SUBJECT: INITIAL COMMENTS LETTER

PROJECT NAME: DARWIN FIGUEROA TRUCK STORAGE & REPAIR SHOP

PROJECT #2020060081

APPLICATION: MAJOR SITE PLAN #26442

Section & Title of Code: 6.8.6 - Buffers
Reason/Justification for Waiver Request: Please see submitted pictures. We request that existing trees be left and a 6' privacy fence be installed at 20'. Existing trees in the roadway Buffer vicinity should meet the requirements of required trees.

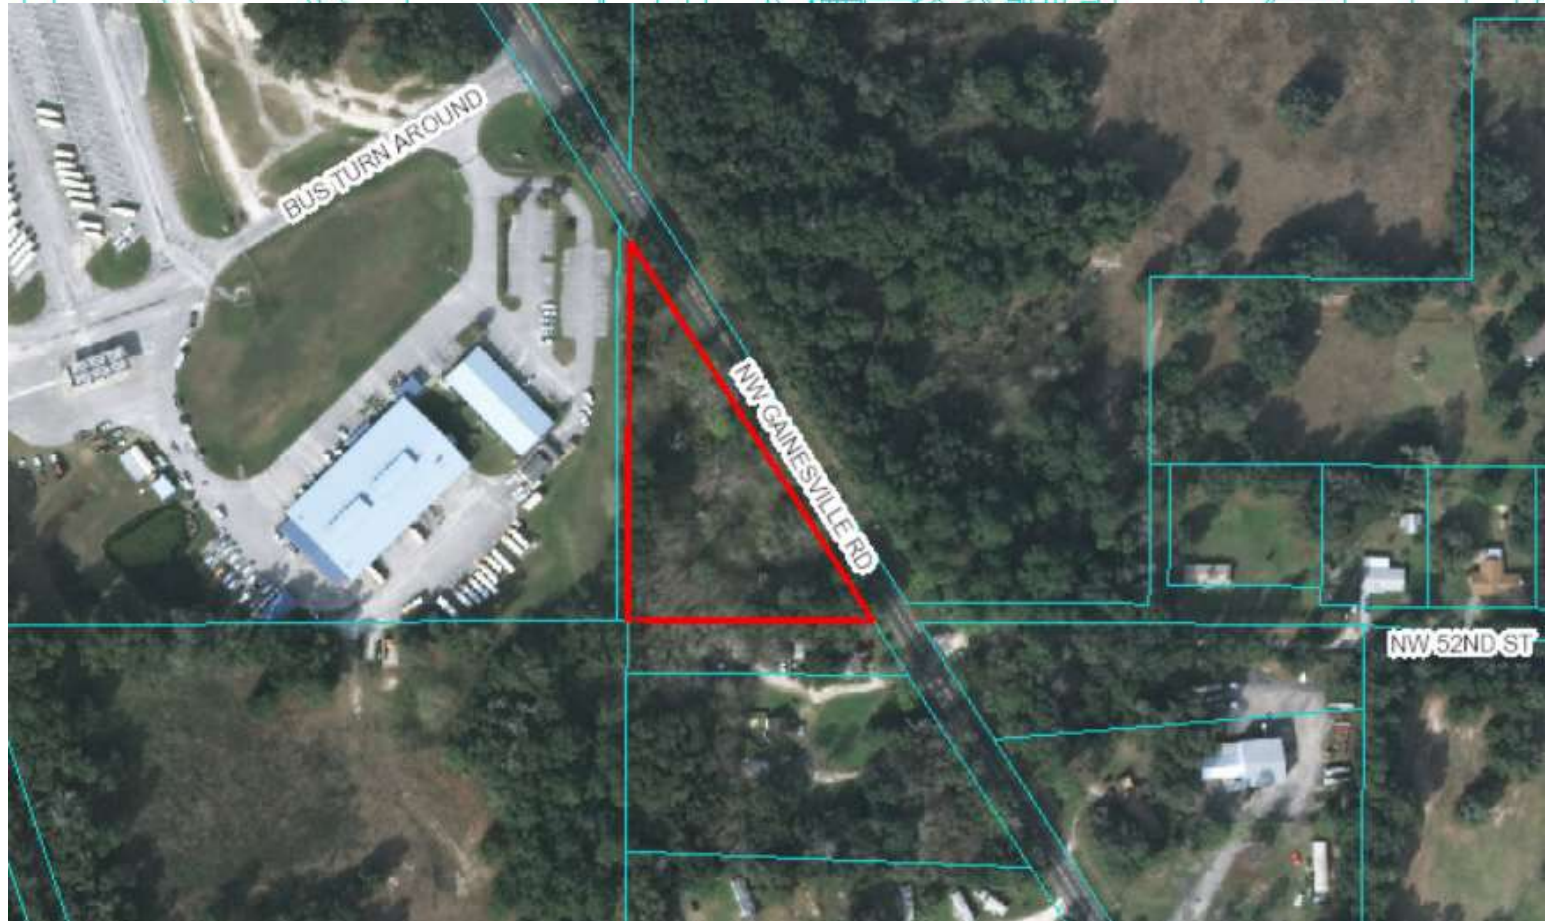
29. DEPARTMENT: LSCAPE - LANDSCAPE DESIGN AND IRRIGATION
REVIEW ITEM: 6.8.6 - Buffers
STATUS OF REVIEW: WAIVER REQUESTED. STAFF CONDITIONALLY SUPPORTS PROVIDED THAT FENCE IS OF STURDY CONSTRUCTION AND DURABLE MATERIAL.
REMARKS: 1. Label Buffers types on plan. 2. Provide calculations showing buffer meets planting requirements. Buffer as shown does not meet requirements. 3. B type buffer required on South property boundary. Show planting area on plans, Waiver will be required for fence instead of a wall.

Section & Title of Code: 6.8.7 - Buffers
Reason/Justification for Waiver Request: Buffer along should provide screening from the parking area. We are preserving 12 more trees than required and planting additonal trees should not be needed.

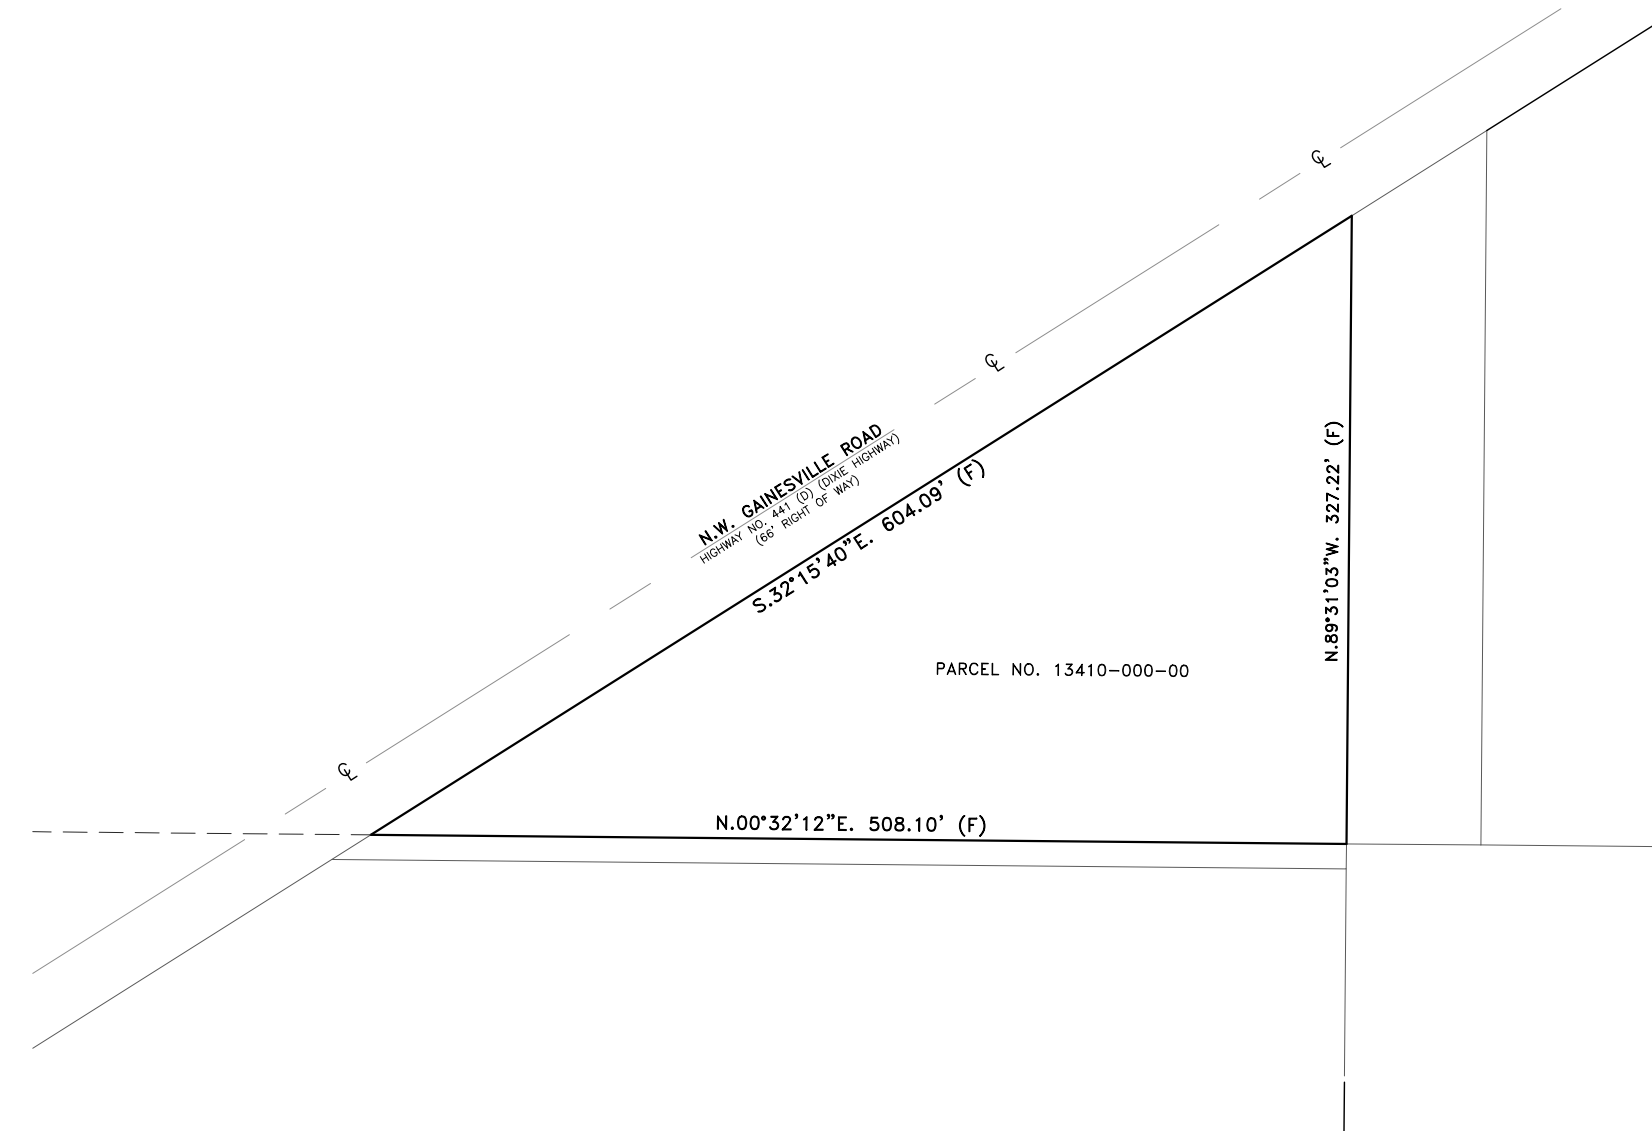
30. DEPARTMENT: LSCAPE - LANDSCAPE DESIGN AND IRRIGATION
REVIEW ITEM: 6.8.7 - Parking areas and vehicular use areas
STATUS OF REVIEW: WAIVER REQUESTED. STAFF DOES NOT SUPPORT.
REMARKS: 1. Parking areas must be screened from road. 2. Parking terminus islands must have a shade tree
